Legislation Details (With Text)

File #:	22-496	Version:	1	Name:	
Type:	Staff Report	Status:		Development Services Staff Report	
File created:	9/22/2022	In control:		Council	
On agenda:	10/3/2022	Final action:			
Title:	Development Variance Permit & Development Permit – 856 & 858 Esquimalt Road, Staff Report No.: DEV-22-091				
Sponsors:					
Indexes:					
Code sections:					
Attachments:	1. Appendix A - DVP00115 - 856_858 Esquimalt Road, 2. Appendix B - DP000166 - 856 & 858 Esquimalt Road, 3. Appendix C - Section 219 Covenant Terms, 4. Appendix D - CD-80 zone, Maps - Air Photo, OCP Designations, DP Areas, Zoning, 5. Appendix E - Architectural Drawings, Landscape Plans, and BCLS Site Plan, 6. Appendix F - Bunt traffic and parking report, 7. Appendix G - DPA No 1_4_6_7_8_11 guideline forms and Green Building Checklist, 8. Appendix H - DVP mail notice – mailed September 20, 2022, 9. Appendix I - PC Urban Open house invite, 10. Appendix J - Applicants Presentation - 856 & 858 Esquimalt Road

DATE: September 27, 2022 Report No. DEV-22-091

Development Variance Permit & Development Permit - 856 & 858 Esquimalt Road

Figure 1.

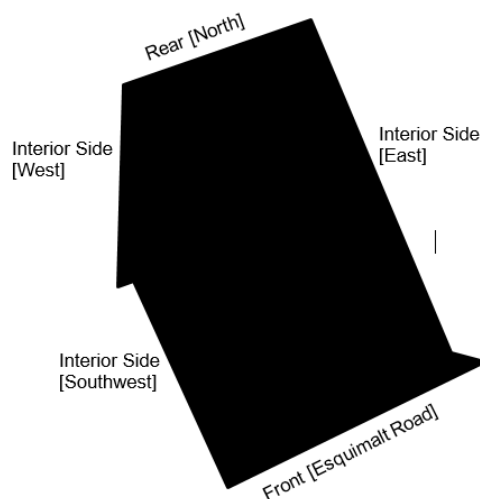
Within this CD-80 Zone, lot lines and setbacks shall be determined in accordance with Figure 1 (below).

(a) Principal Buildings

- (i) No Building shall be located within 7.1 metres of the Front [Esquimalt Road] Lot Line.
- (ii) The northwest wing of the southern Principal Building [Building A] shall not be located within 4.3 metres of the Interior Side [West] Lot Line.

- (iii) The southwest corner of the southern Principal Building [Building A] shall not be located within 3.1 metres of the Interior Side [Southwest] Lot Line.

- (iv) The western wing of the southern Principal Building [Building A] shall not be located within 11.9 metres of the Interior Side [East] Lot Line.
- (v) No Building shall be located within 7.5 metres of the Rear [North] Lot Line.

- (vi) The northern Principal Building [Building B] shall not be located within 7.7 metres of the Interior Side [East] Lot Line.
- (vii) The northern Principal Building [Building B] shall not be located within 6.4 metres of the Interior Side [West] Lot Line.

- (viii) The separation between the east wing of the southern Principal Building [Building A] and the south wing of the northern Principal Building [Building B] shall not be less than 17.5 metres.

- (ix) The separation between the northwest wing of the southern Principal Building [Building A] and the west wing of the northern Principal Building [Building B] shall not be less than 12.5 metres.

- (x) The separation between the northwestern wing of the southern Principal Building [Building A] and the south wing of the northern Principal Building [Building B] shall not be less than 20.0 metres.
